RECEIPT DATE: 8131	ONSITE SEWAGE DISPOS	SAL SYSTEM	2563980			
APPROVAL DATE: 08 206	PERMIT: CONS	TRUCTION	A			
PROPERTY ADDRESS: 12	535 Westland Court					
SUBDIVISION: Westland I	Farm Estates	LOT: 9 TAX ID:	05-4433490			
CONTRACTOR: PAR	50 519 day 00 5 Tull	ATEMAIL: VI	Δ			
CONTRACTOR ADDRESS:	Hernelds	10/1	DNE: 301 490 428°			
PROPERTY OWNER: Willi	amsburg Group LLC	EMAIL:N/A				
OWNER ADDRESS: 5485 Har	pers Farm Road, Columbia, MD 21044	PHONE:	410-997-8800			
SEPTIC TANK SIZE (GALLONS):	2000 TANK MANUF	ACTURER: Babylon Vaul				
PUMP MODEL: N/A	PUMP SIZE N/A	PUMP TANK CAPACIT	Y: N/A			
DISTRIBUTION SYSTEM:	☑ GRAVITY ☐ PRESSURE DOSE	D BEDROOMS: 6 AI	PPLICATION RATE: 1.2			
LINEAR FEET R	EQUIRED: 99 124 LF (100)	INLET DE	PTH: <b>3.5</b>			
	H WIDTH: 2 2	MAXIMUM BOTTOM DE	PTH: 8 🗸			
I PE MONTH A PER	JM SPACE RENCHES: 12	EFFECTIVE AREA BEGINNING DEI	РТН: <b>3.5</b>			
LOCATION: I	SITE PLAN. SEWAGE DISPOSAL AREA AND OR TO PRE-CONSTRUCTION INSPECTION.	TANK LOCATIONS MUST BE ST	TAKED BY LICENSED

SEPTIC PLAN WESTLAND FARM ESTATES LOT 9

Westland Farm Estates

"Septic Plan Comments"

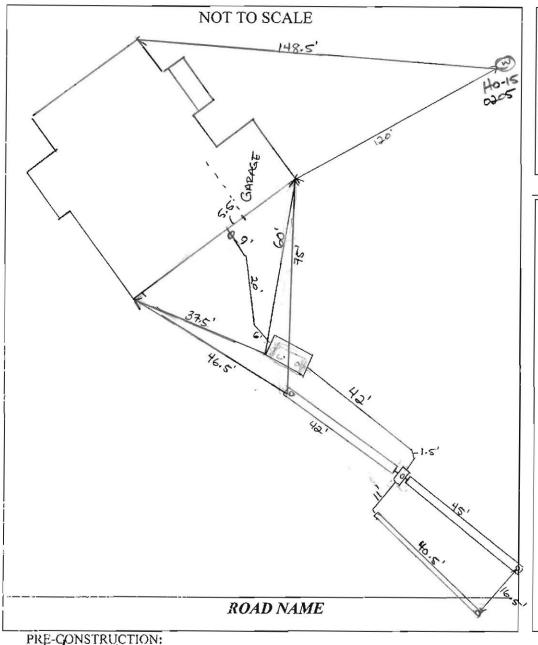
PIED THE S.T. TOWARD THE DRIVEWAY TO HELP FALL. EXTENDED THE UPPER TRENCHES A FEW PEET OUT OF SDA TO MAKE 2' NIDE. (R)

INSTALLATION: 8/17/2018 SENTER HOUSE CONNECTION INSTALLED. SENTER LINE FROM
HOUSE TO SEPTIC TANK INSTALLED. TANK SET. FALL IS DK. EFFLUENT LINE
FROM TANK TO D. BOX SET. D LOK PLACED and TWO DETAL TRENCHES COMPLETE.
REINSPECT FOR PROXIMAL TRENCH CONSTRUCTION AND SPEED LEVEL DROC.
DK TO COUBR WORK @ 8/20/2018 FINAL TRENCH COMPLETE. D 82x LEVELED.

OK TO BACKFILL

SEPTIC PLAN WESTLAND FARM ESTATES LOT 9

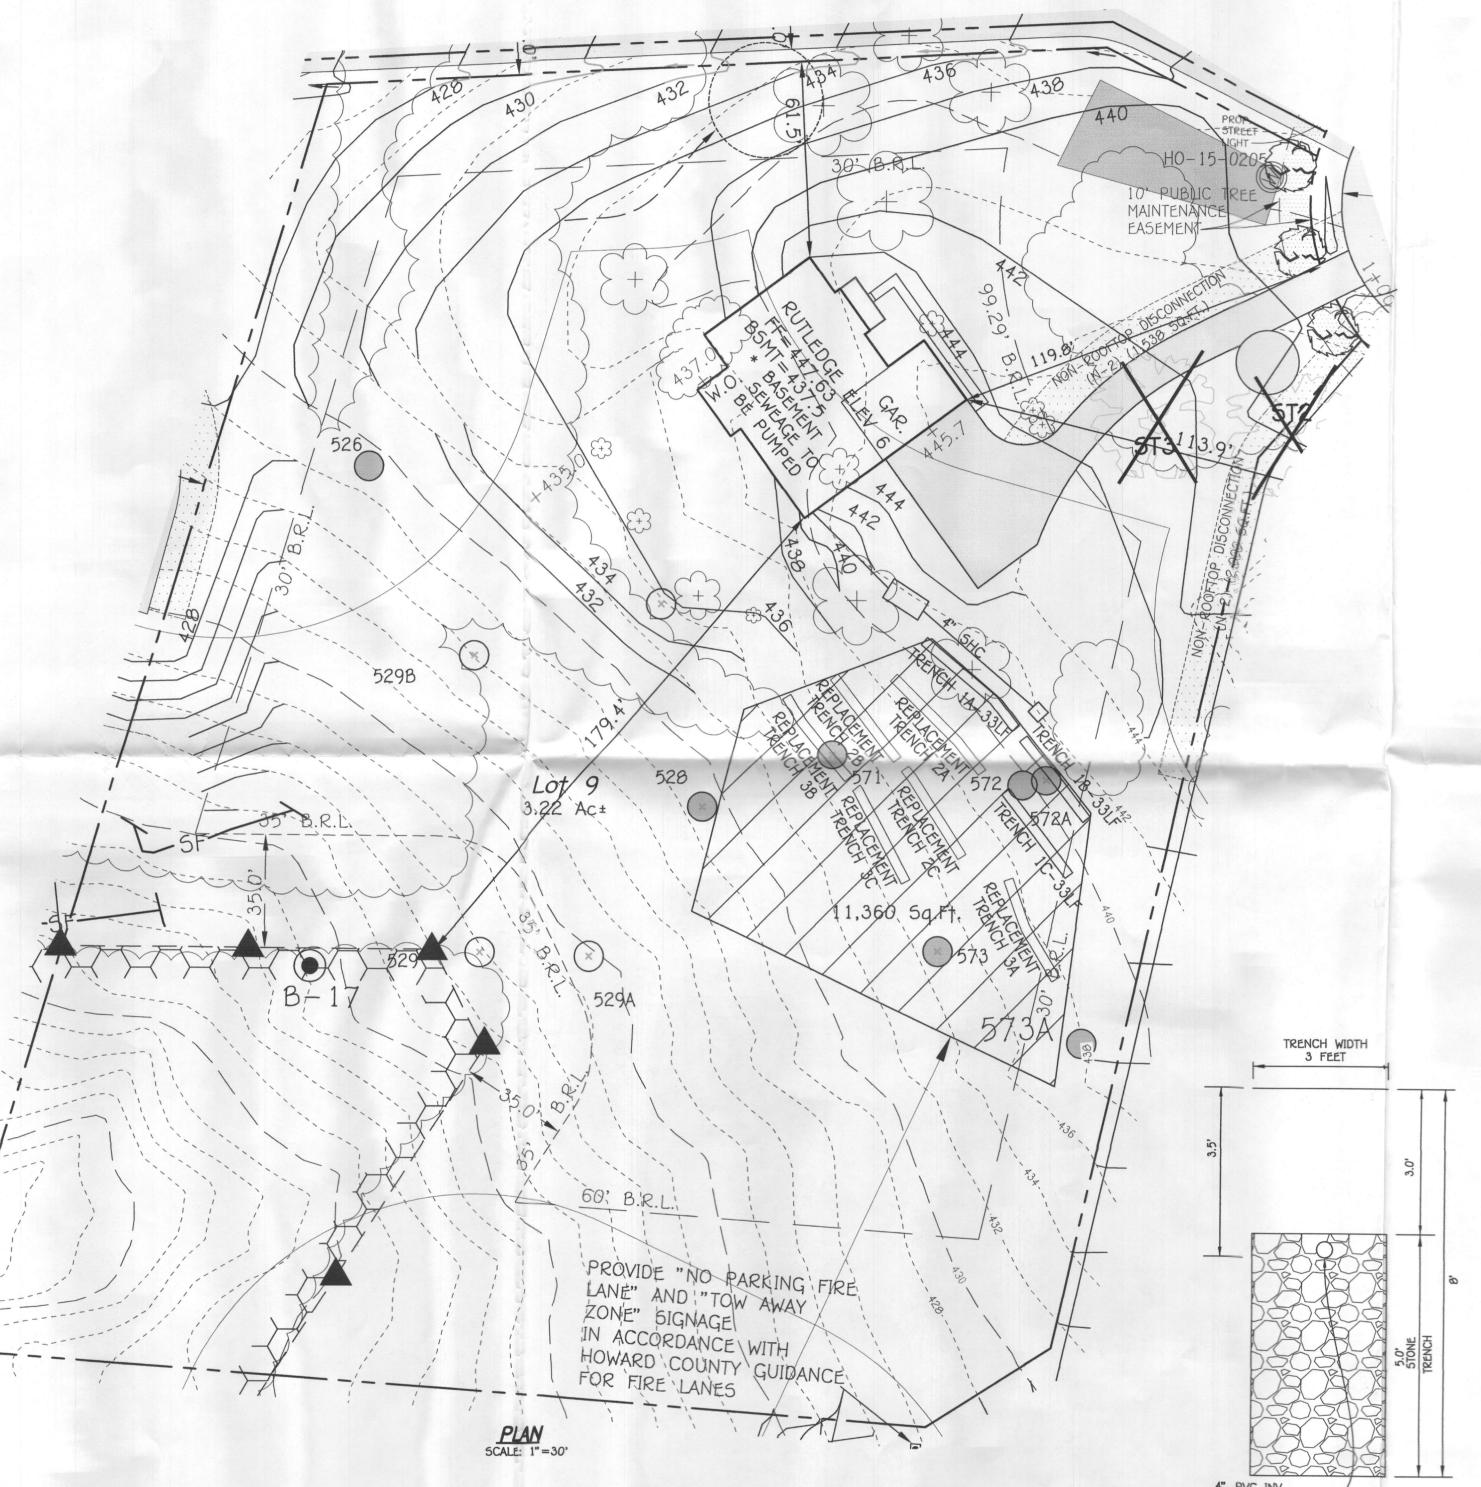
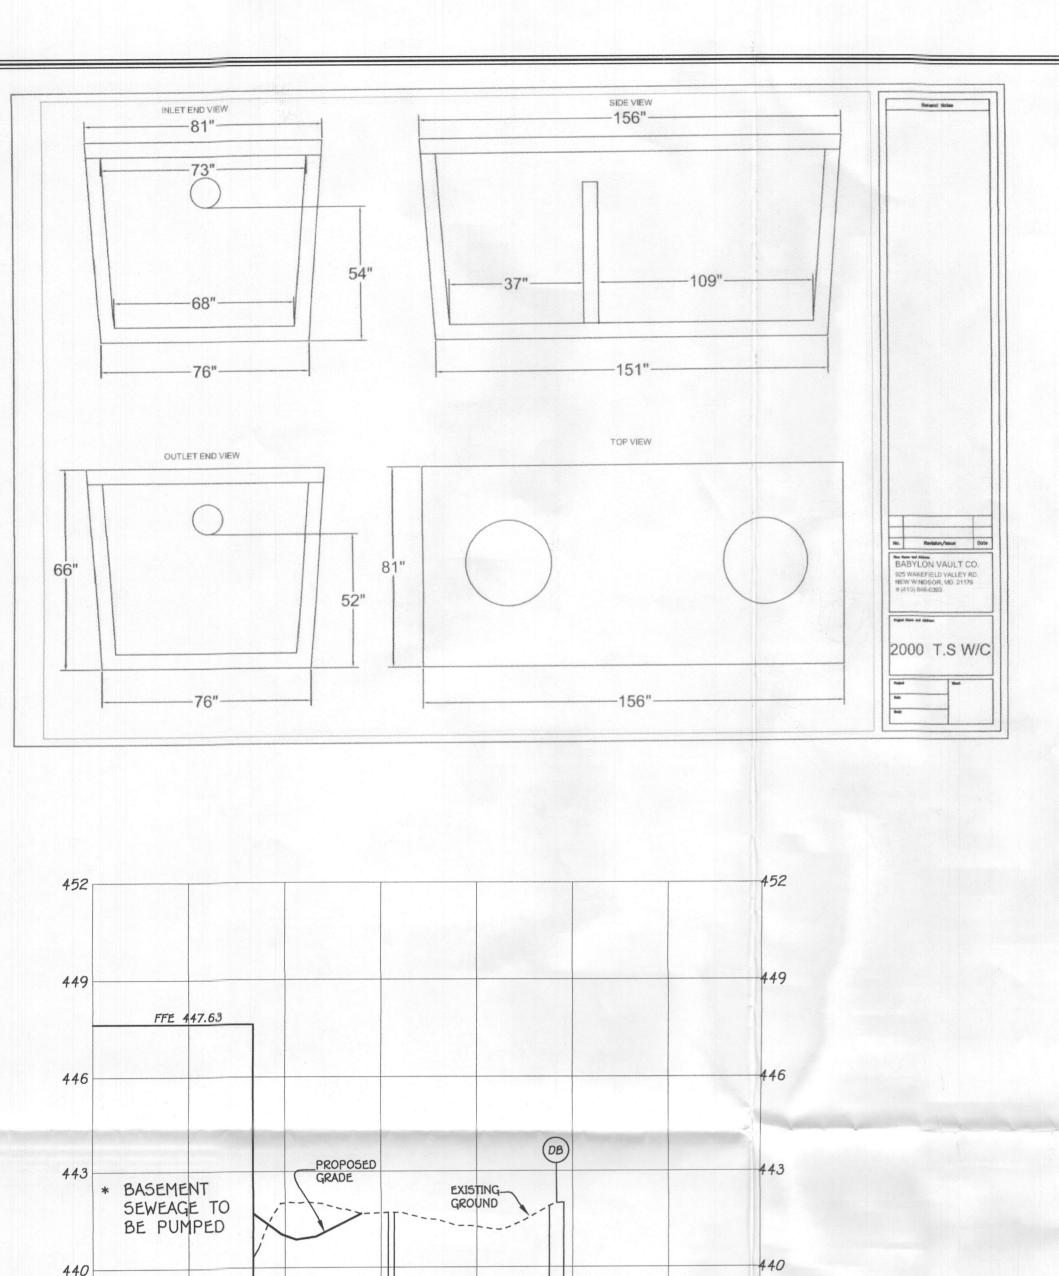
After review of the septic plan here are my comments.

• The well box is in a different spot than what was approved on the 6/8/2016 Perc Cert.

• In the Sewage Disposal System Data calculations it mentions both 5 and 6 bedrooms. The building permit is for 6 bedrooms.

• The *Trench Design* only shows elevations for 2 of the 3 trenches.

• The existing septic system on the property must be abandoned with documentation sent to the Health Dept. If already abandoned documentation of it must be sent to the Health Dept.
